- 8. Lucason Subdivision 2025 Replat; KPB File 2025-016
Johnson Surveying / Stokes, Demidoff
Location: MP 137 Sterling Highway & Auntie Mae Drive
Happy Valley Area**

Lucason Subdivision 2025 Replat PRELIMINARY PLAT

**ITEM #8 - PRELIMINARY PLAT
LUCASON SUBDIVISION 2025 REPLAT**

STAFF REPORT

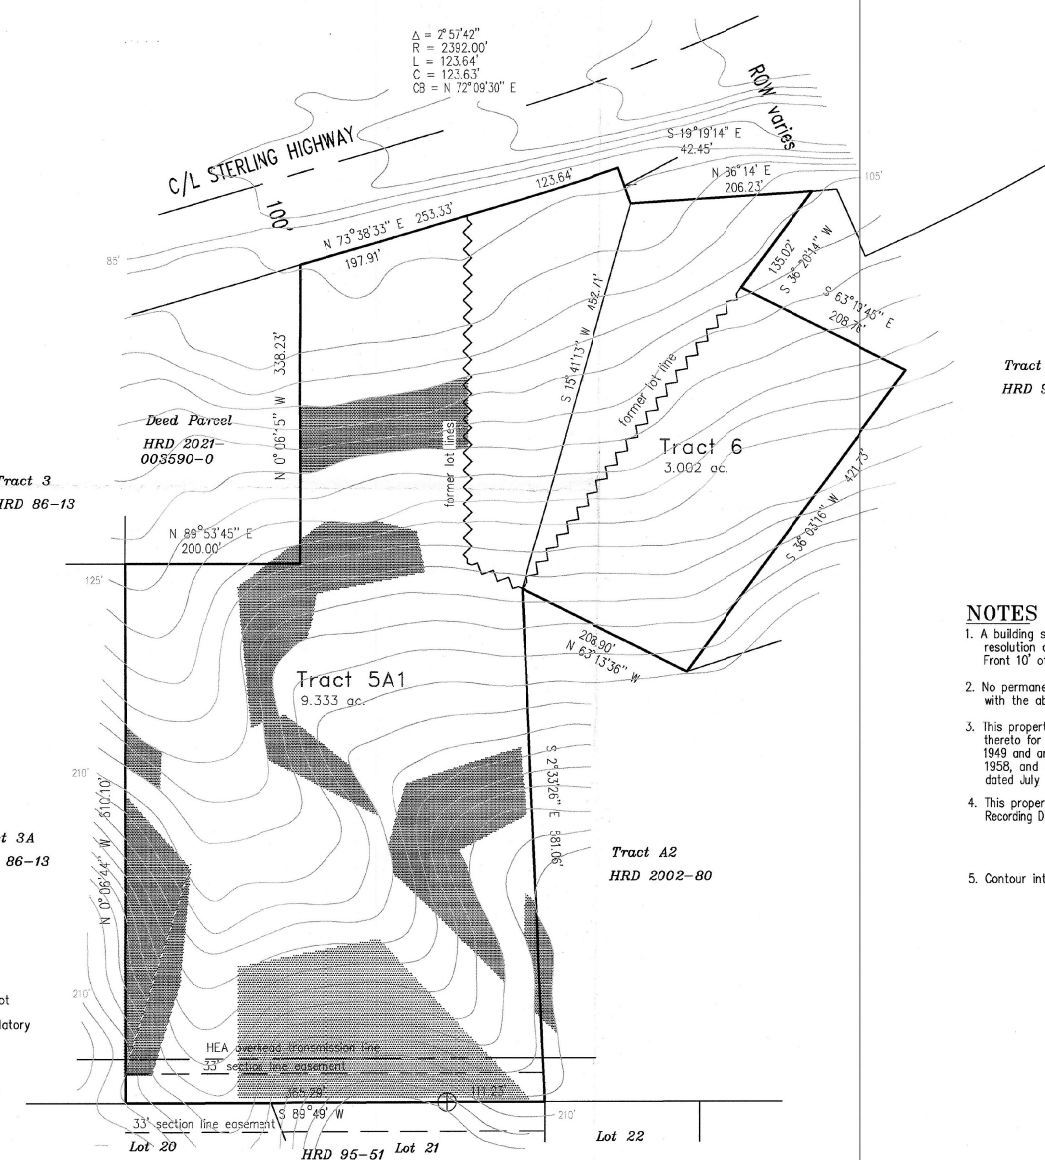
The plat is affected by a 33' section line easement on the south line as shown on the drawing.

The plat is affected by Auntie Mae Dr crossing the property on the two angled points in the northeastern corners near the Sterling Highway to get to the adjacent properties further to the east and to the east end of proposed Tract 6. There may need to be some access easements needed to be created between land owners to clear up any issues. **Staff recommends** the surveyor locate the portion of auntie Mae Dr crossing the property lines and address any issues as needed.

There are steep areas located on the proposed plat. the steep areas are shown on the drawing as the dark shaded areas. Staff recommends the contours be removed for the final submittal and arrows be added to show direction of fall for the steep areas.

The River Center review identified the plat to be located in a FEMA designated flood hazard area. The flood hazard notice as shown in KPB 20.30.280 should be added to the plat notes, including the FEMA FIRM Panel and Zones in the note. The line of the FEMA Zones needs to also be shown on the drawing with zone identified.

There are 10' utility easements located on Tract 5A of Lucason Subdivision 2002 Addition HM2002-80 that need to be shown on the drawing. These easements are on the front, and west line and also along the former lot line shown on the plat.

There is a 100' HEA Transmission Line Easement that needs to be properly labeled on the plat.

The plat is adding 10' utility easements along the right-of-way of the Sterling Highway, east of former Tract 5A, this easement needs to also be added to the drawing. the portion that widens to 20 feet within 5 feet of side property lines needs to be added also.

- Add reference to item 7 in certificate to plat on drawing
- Add reference to the easement in the certificate to plat at item #8.
- Add the 10' utility easements as shown on Lucason Subdivision 2002 Addition, including along the former lot lines.
- Correctly label the Overhead Transmission Line Easement per HM2002-80

- Staff recommendation:**
Add the KPB File no 2025-016 to the title block
- C. The location, width, and name of existing or platted streets and public ways, railroad rights-of-way, and other important features such as section lines or political subdivisions or municipal corporation boundaries abutting the subdivision;

- Staff recommendation:**
Auntie Mae Dr is located within Sterling Highway ROW, need to give documentation of the history of the usage and location in the notes.
Give the full ROW width of the Sterling Highway on the drawing

- Staff recommendation:**
Correct Section 35 under Cook Inlet

Lot labels to the east and south are with a dash (A-2 and B-1)

Correct the plat filing labels on the lots across the south
